TITLE: [PR-CM] Development Application DA10/0222.26 for an Amendment to Development Consent DA10/0222 for Casuarina Town Centre Including 56 Lot Subdivision, Road Works, Infrastructure Works and Landscaping (Department of Planning Application MP06_0258) MOD 10 at Lot 15 DP 1198266 Casuarina Way, Casuarina

This report has been prepared to provide Council with an overview of staff comments in relation to the proposed modifications to the approved Concept Approval and Project Approval for the Casuarina Town Centre development (MP06_0258).

That Council endorses the comments to be submitted to NSW Planning & Environment with regard to all proposed modifications of the Concept Approval and Project Approval relating to Casuarina Town Centre (MP06_0258) MOD 10.

Figure 6: Proposed Allotment Layout

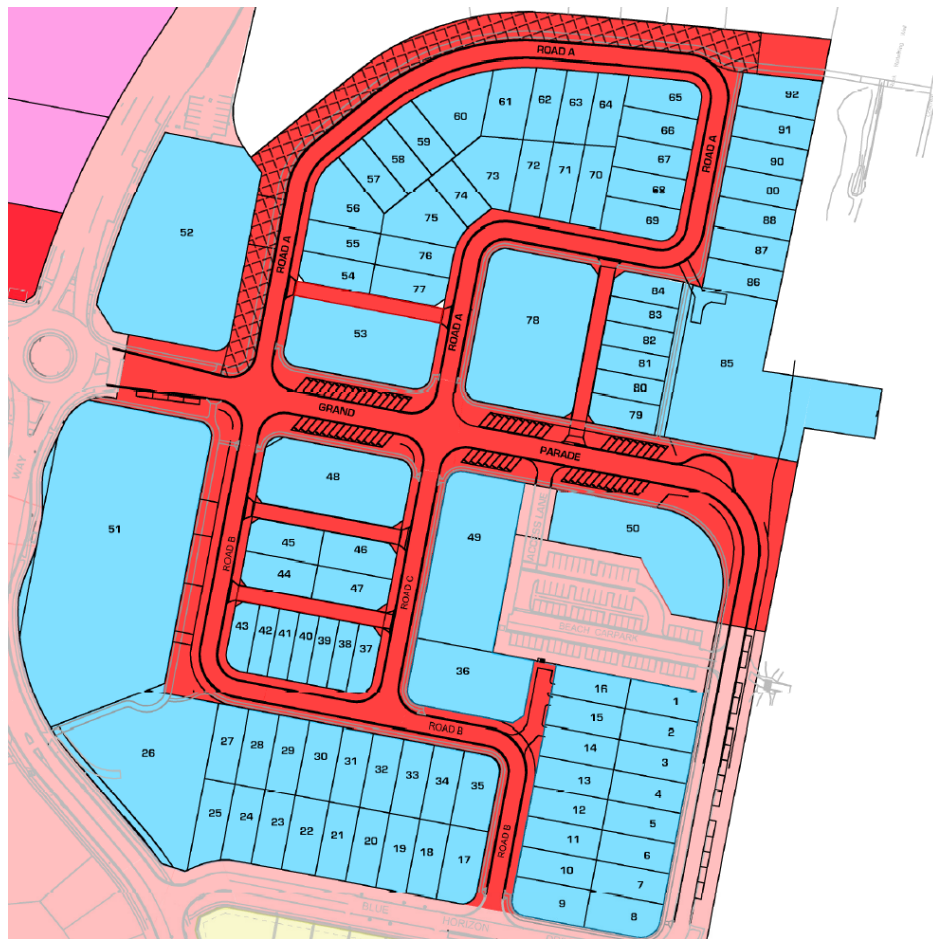
The proposed modification results in an amended allotment layout design as outlined under figures 6-8 above. It is noted that this amended layout will result in a reduction in density of development on site. The Economic Impact Assessment submitted as part of this application outlines the following with respect to this;

The modification application now submitted seeks to further reduce the density of development over this area by an additional 144 dwellings. Tweed Shire Council would again request that Department of Planning & Environment assess this as a reduction to the density of the overall Casuarina Town Centre development and consider its suitability from an holistic perspective regarding potential impacts on the Casuarina Town Centre Development.

Figure 7: Proposed Layout (North)

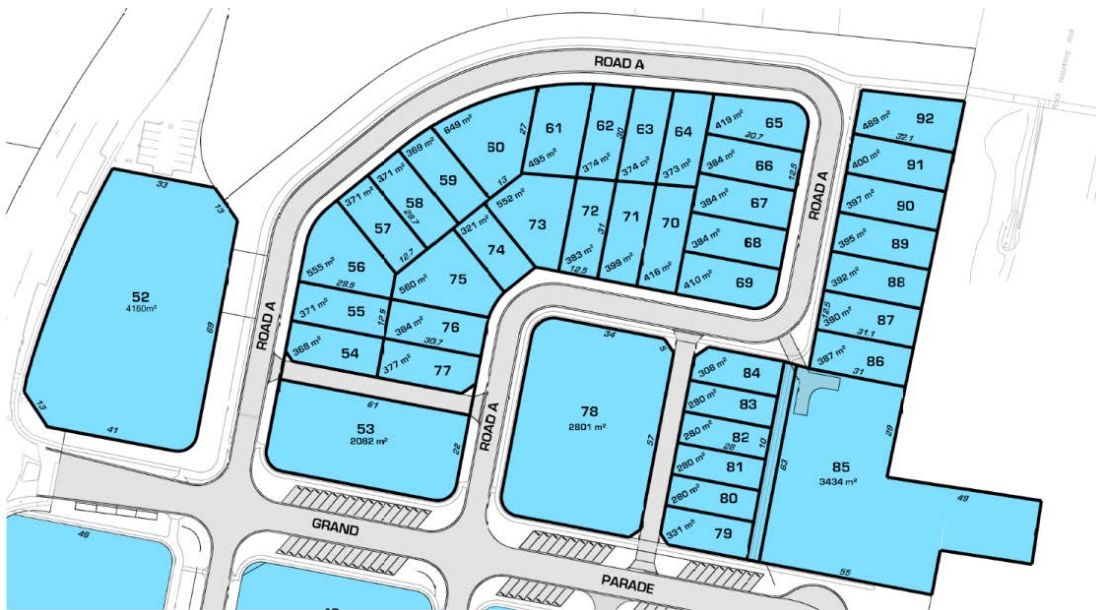
Concerns are raised with respect to the extent and number of retaining walls proposed under the modified layout. Council’s Development Engineering Unit has advised the following with respect to this;

- Tweed Shire Councils Development Design Specification – D6 Site Regrading (TSC-D6) specifies that the maximum permissible combined of retaining walls or batters in residential subdivisions shall be 1.8m above street level and 2.4m below street level. The proposal to have a retaining wall up to 4m in a residential subdivision (adjacent to proposed Lot 92) does not comply with TSC – D6.

Figure 13: Approved Easement

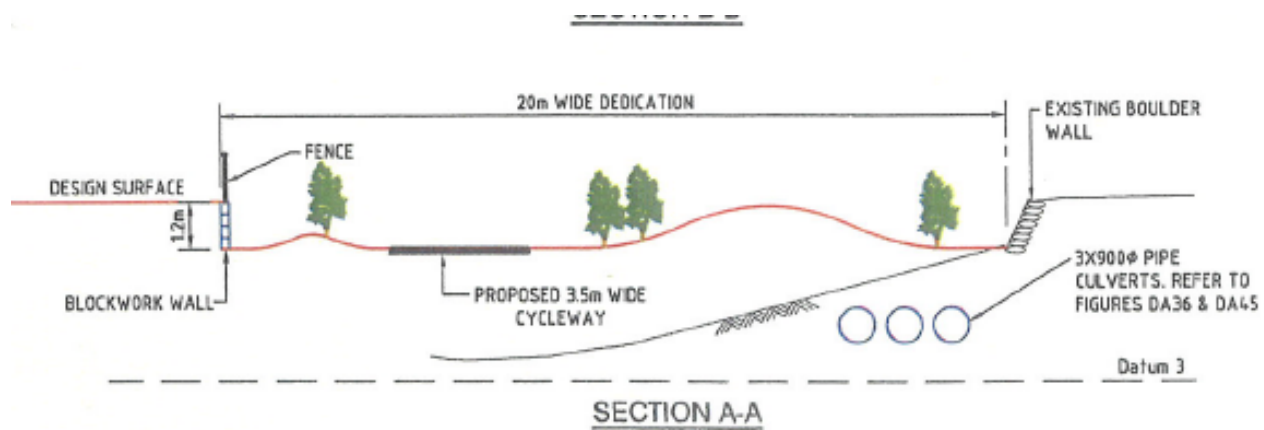
The drainage swale provides a high capacity connection between the coastal swale that services the Casuarina Estate and an outlet to Cudgen Creek to the west. It provides a high degree of infiltration due to the sandy soil. Taking into account the design specifications provided by the existing consent and Council's D5 specification, the modification application proposes to replace the open swale with large diameter pipes (3 x 1650mm pipes) to cater for the Q100 flow. Modelling demonstrates that this piped configuration does not increase upstream flood levels in extreme events, or increase the incidence of the coastal swale overtopping the dune to the beach. This would allow for the overall easement width to be reduced, provided equivalent infiltration can be achieved elsewhere in the trunk drainage system. As such, there is no hydraulic reason to oppose the piping of the swale drain, only the public benefits afforded by the wider easement.

Detail of the proposed configuration of the area within the easement is difficult to locate in the modification application. It is assumed that the area will be dedicated as a widened road reserve, containing landscaped vegetation for the first 8m from the northern boundary, a 2.5m wide cycleway, and then a local access street, up to the front boundary of low density residential allotments. The 3x1650 stormwater pipes, a realigned sewer, as well as necessary water services, telecommunications and street lighting will be provided within this area.

It is requested that the applicant provide a clear cross section showing all above and below ground infrastructure, landforming batters and retaining structures, and clearances between the various uses e.g. Vegetation, cycleway, roadway, verge widths, and piped infrastructure. Without such detail, it is suspected that inadequate width has been allowed for in the design, noting that approved 20m wide drainage reserve in the current approval did not include road infrastructure.

Council would request that the Department of Planning & Environment give consideration to the public submissions received with respect to this element of the modification and it is considered that without sufficient justification for a change to the approved layout, Council would prefer that the existing arrangement remain to this area.

Figure 15: Concept drawing of proposed 8m wide buffer

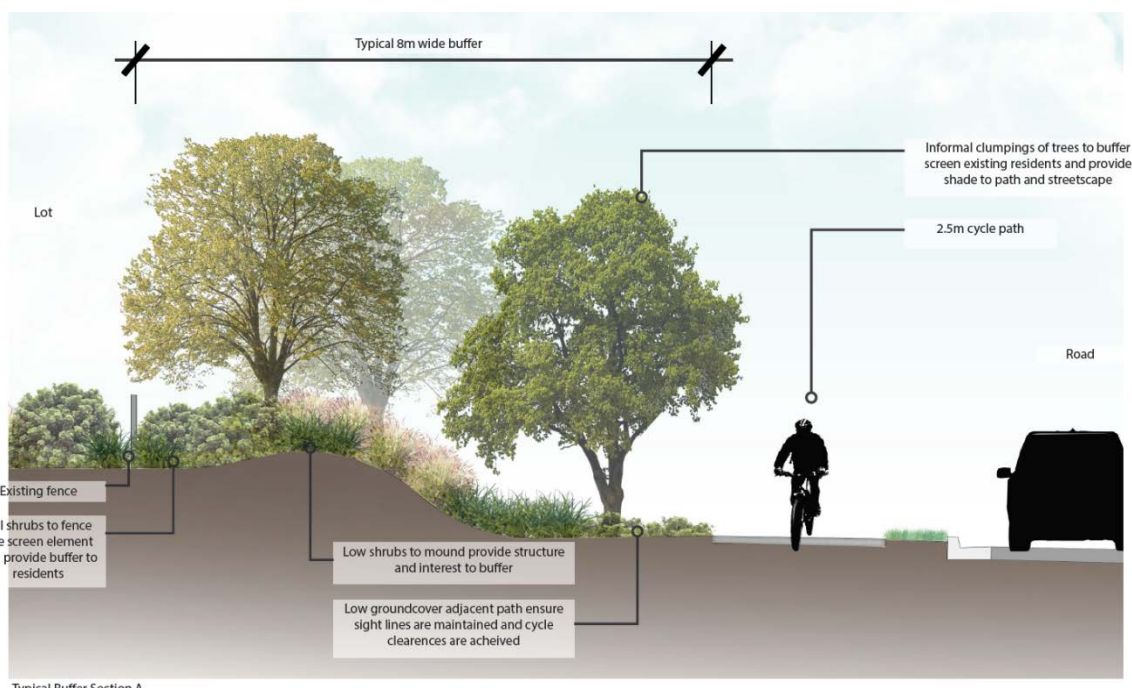
- Regarding planting on the "8 metre wide buffer to rear of properties includes planted mounds, informal shrub and ground cover plantings.....", these will need to be carefully designed to ensure minimal maintenance to the plantings will be required long term. This is important as this is not a park and won't be maintained in the same way as parks are.

Figure 16: Proposed Staging plan

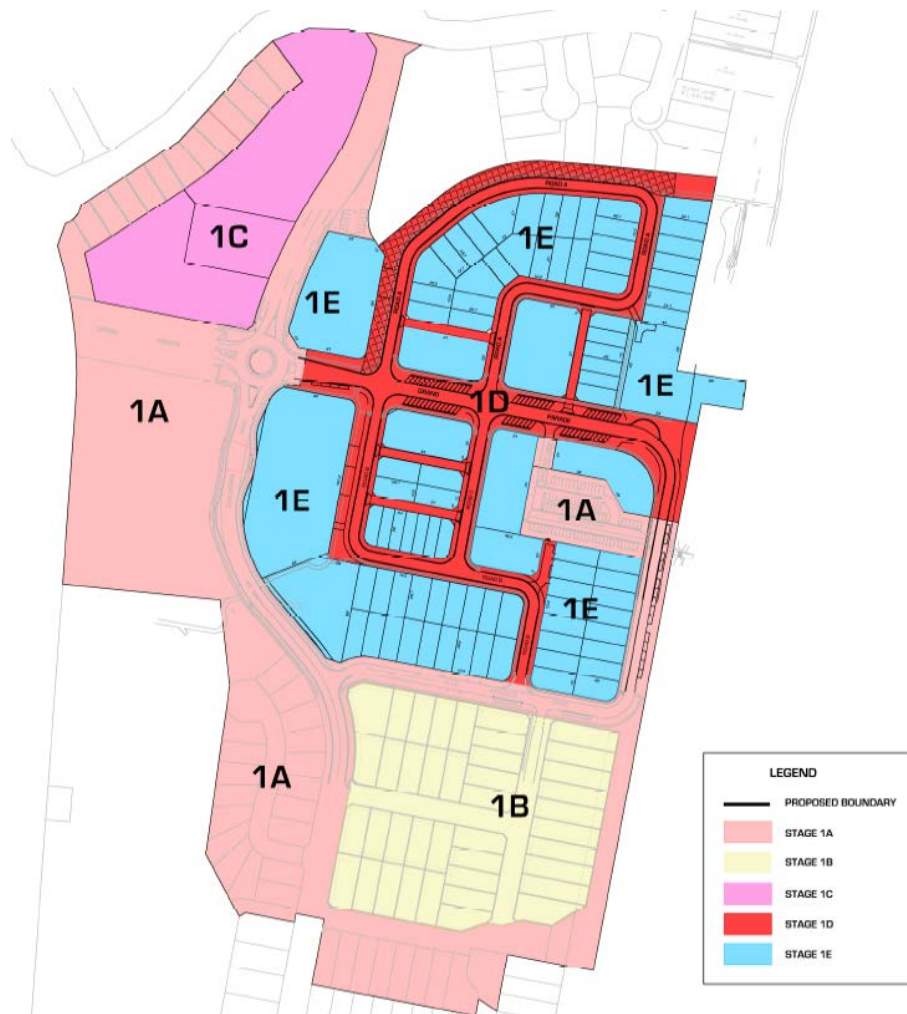
Council do not have any specific objections to the staging of the development in this manner, provided the provision of infrastructure (Stage 1D) occurs prior to the release of allotments (Stage 1E).

It is noted that Development Sequence Plan (Drawing No. 13/054), prepared by Newton Denny Chapelle and dated 21 December 2015 demonstrates an allotment to the west of Casuarina Way as part of Stage 1D works. The Department of Planning and Environment are requested to clarify whether it is intended to incorporate this site into Stage 1D works.

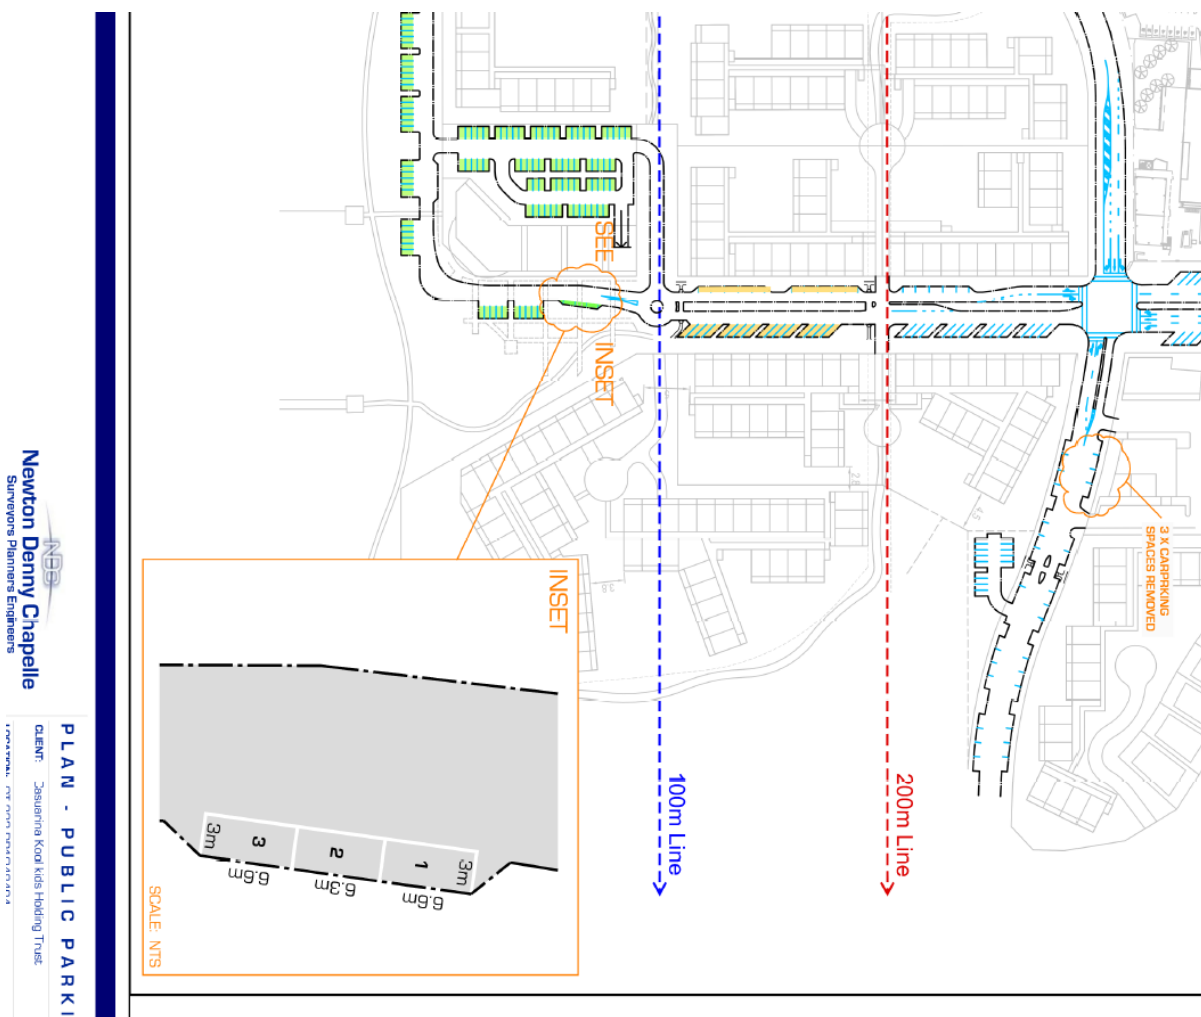
- The existing approval includes a proposed 3.5m wide cycleway connecting from Casuarina Way to Casuarina foreshore along an easement of various widths. In addition the approval provides an additional cycleway connection to Casuarina Way near the existing Santi building.

The proposed modification now seeks to reduce the proposed cycleway width from 3.5m to 2.5m and delete the additional cycleway connection to Casuarina Way near the existing Santi building. The cycleway width of 3.5m and cycleway connection to Casuarina Way near the existing Santi building is to remain as per approved.

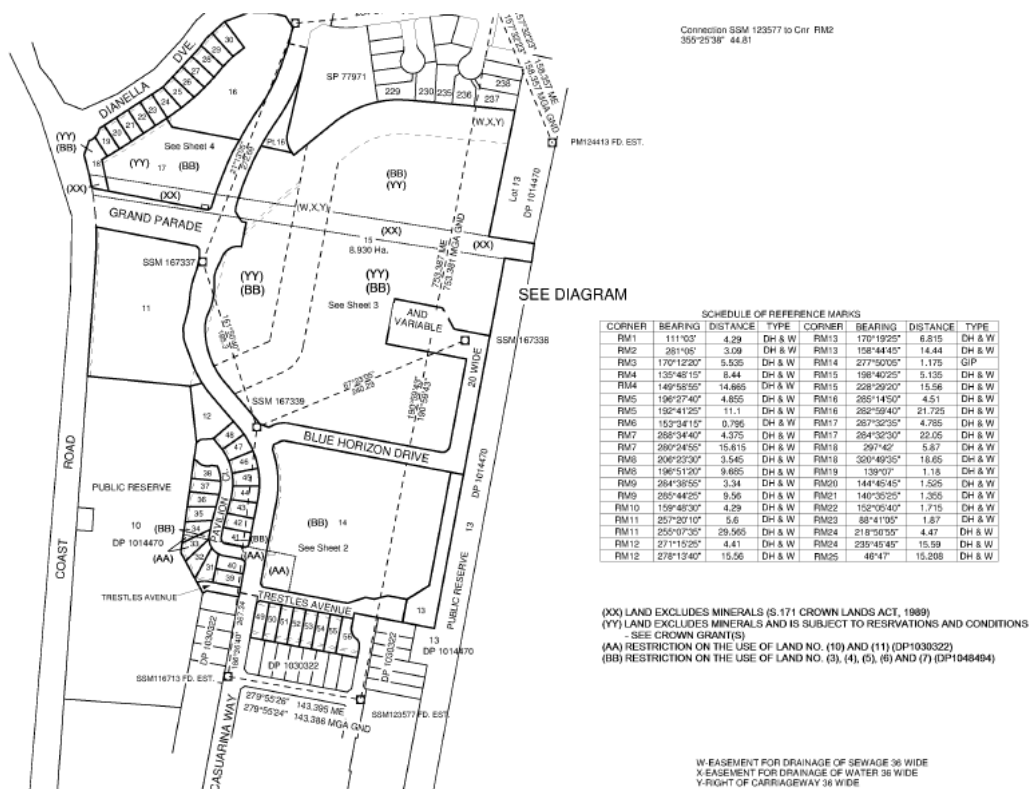
The current proposal does not acknowledge this previous advice, or attempt to address the urban design issues associated with the proposed changes to the easement and associated works. As such, there is no justification for Council to change the viewpoint of opposing piping of the whole swale, and no changes to the existing easement benefiting Council will be supported.
